802.3dj D3.0

Comment Resolution

Electrical Topics

Introduction

Vf (Preset 1) –vs- Rpeak

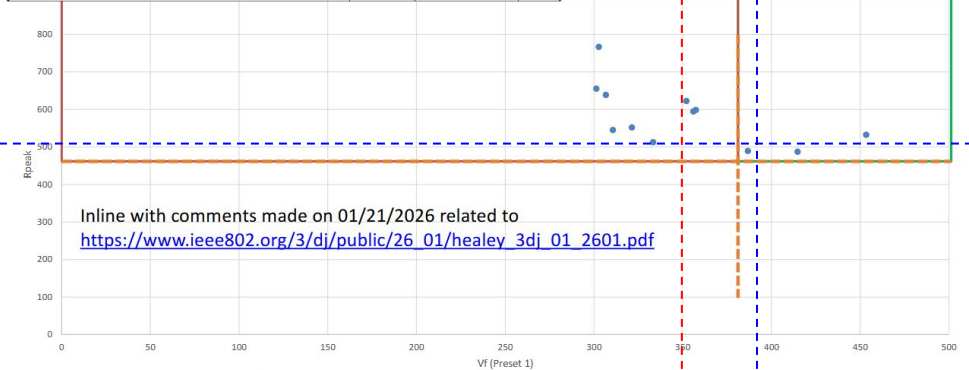
Vf minimum value of .389V still fails the majority of early designs.

The interop report out:
https://www.ieee802.org/3/dj/public/26_01/calvin_3dj_01a_2601.pdf Page 23 shows 9 out of 12 modules failing Vf. We either need to review the measurement methodology in Vf (which is not new) or consider further reduction of the Vf values to 350mV.

Blue overlay lines show (approximately) the new limit values proposed by comment #175.
 Red overlay line shows the new limit value proposed by comment #277.

PROPOSED REJECT.
 The v_f specification is an important component of the COM analysis that supports the loss budget of 32 dB for C2M applications. Reducing the minimum v_f would undermine this analysis and prevent interoperability with worst-case hosts.
 The information in the referenced presentation does not justify reducing the v_f limits. It shows that some of the tested modules met the requirements. Devices that failed the requirements might have not been configured correctly or might be non-compliant.
 [Editor's note: changed clause/subclause/page from 179D/179D.6.3/821 to 176D/176D.6.5/822]

Figure 179B-3—Mated test fixtures common-mode to differential-mode insertion loss requirements

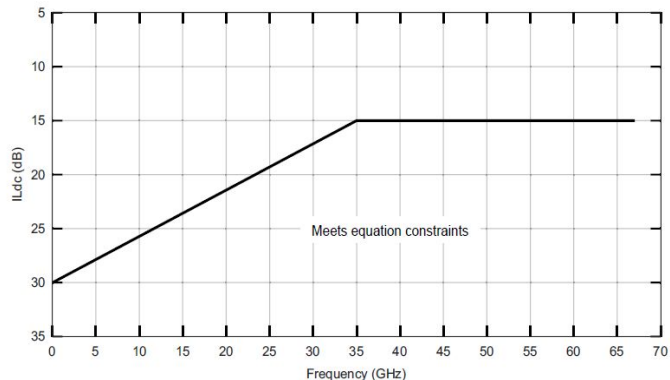
Intrapair skew has not been directly considered for the MTF. Although intrapair skew is included in the computed differential mode to differential mode insertion loss, the effect of skew has not been explicitly specified. Common mode to differential mode insertion loss does contain elements of skew. An either or specification for SCMR_CH should be added to control MTF intrapair skew.

The common-mode to differential-mode insertion loss of the mated test fixtures measured in both directions shall meet Equation (179B-6) as illustrated in Figure 179B-3. or the channel signal to common-mode ratio (SCMR_CH) shall exceed 12 dB using the procedure described in 179.11.7.

The comment suggests adding a minimum SCMR_CH of 12 dB as an alternative to the frequency mask of Equation 179B-6.

SCMR_CH is a specification of cable assemblies. The specifications of test fixtures cannot rely on the cable assemblies they are used to measure.

Note also that the mated test fixture includes an HCB which has no other specification of mismatch.

The text of the suggested remedy is unclear.

The minimum SCMR_CH specification of cable assemblies is 12 dB, and it seems that the mated test fixtures should be significantly better than that (cable assembly measurement includes two MCBs).

"The mated test fixture shall comply with at least one of the following conditions:

- The common-mode to differential-mode insertion loss of the mated test fixtures measured in both directions meets Equation (179B-6) as illustrated in Figure 179B-3.
- The channel signal to common-mode ratio (SCMR_CH) is greater than <x> dB using the procedure described in 179.11.7."

Figure 178A-2—Single-ended and mixed-mode S-parameters

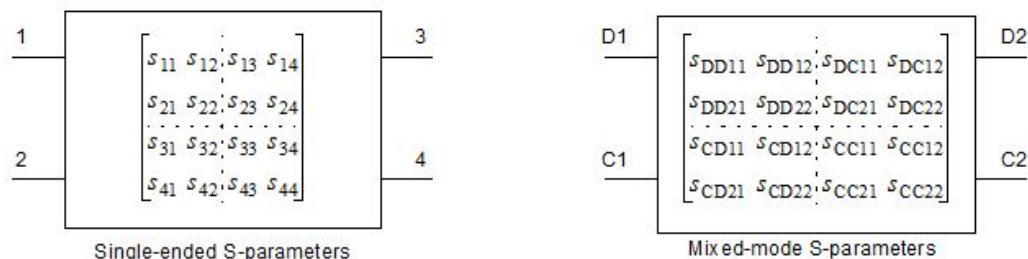
- Comment #153 proposes to add a definition of modal S-parameters to Annex 178A to support modal ERL definitions
- This is also covered [mellitz_3dj_02_2605](#), but the proposed definition seems incomplete and out of place
- Also, Annex 178A pertains to channels and modal ERL is also proposed for transmitters and receivers

- With regard to the definition of mixed-mode S-parameters, we usually try to avoid including extensive tutorial material in the standard
- However, it seem prudent to provide at least some rudimentary definition of the parameters subject to specification
- The text in the following slides is proposed to be used to address comments #153 and #154.

Figure 178A-2 illustrates 4-port single-ended S-parameters $S^{(s)}$ and the corresponding mixed-mode S-parameters $S^{(m)}$ at any given frequency. COM is computed using the differential-mode S-parameters which are taken from the upper-left quadrant of mixed-mode S-parameter matrix. Other mixed mode S-parameters may be used as the basis for other specifications.

The reference impedance for the ~~differential-mode single-ended~~ S-parameters is required to be ~~twice~~ the single-ended reference resistance R_0 specified for the calculation of COM. Note that the differential reference impedance is $2R_0$ and the common-mode reference impedance is $R_0/2$. When the single-ended reference impedance for the measurement ~~$R_m - R_x$~~ differs from R_0 , the measured ~~differential-mode single-ended~~ S-parameters $S^{(m)}$ are transformed using Equation (178A-4) where n is ~~2, Z_0 is $2R_0$, and Z_m is $2R_m$~~ the number of ports represented by $S^{(x)}$.
